Addendum 53 – UN Regulation No. 54

Revision 3 - Amendment 6

Supplement 24 to the original version of the Regulation – Date of entry into force:
30 September 2021

Uniform provisions concerning the approval of pneumatic tyres for commercial vehicles and their trailers

Figure, amend to read:

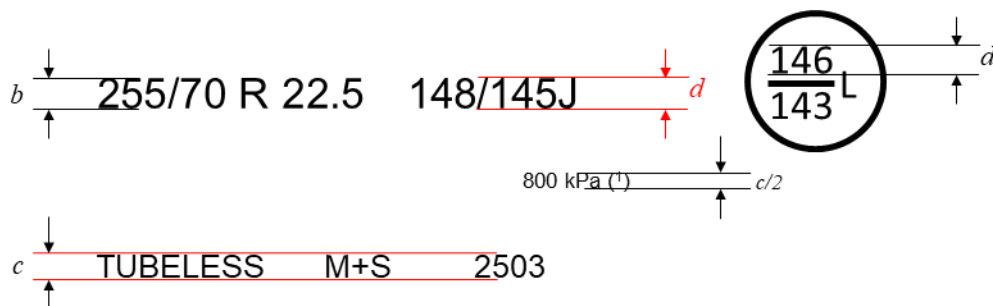
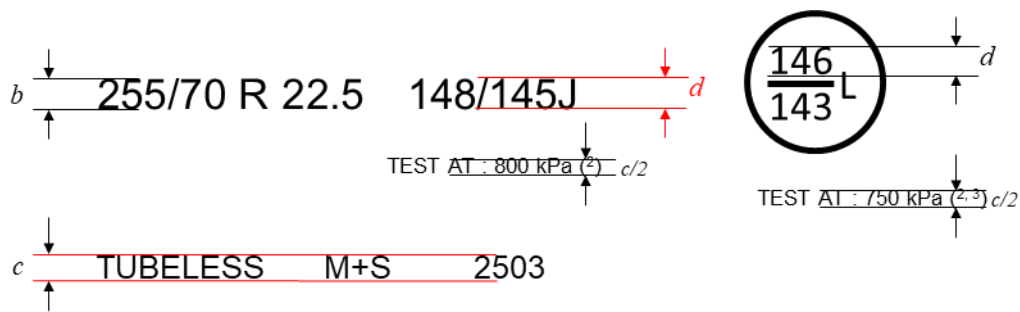
Annex 3

"Example 1:

(1) PSI marking instead of kPa is allowed for tyres first type approved before 1 January 2018. The kPa marking may be preceded by "TEST AT : " or, alternatively, by "TEST INFL : " or the symbol "@".

Example 2:

- (²) "TEST AT :" may be replaced by "TEST INFL :" or the symbol "@" or be omitted.
- (³) The indication of a second inflation pressure for the additional service description is optional. If there is no indication, the same test inflation applies to both load/speed combinations.

Dimensional requirements for further markings (⁴):

- (⁴) For "ML" and "MPT" being part of the tyre size designation marking the minimum dimension *b* applies."
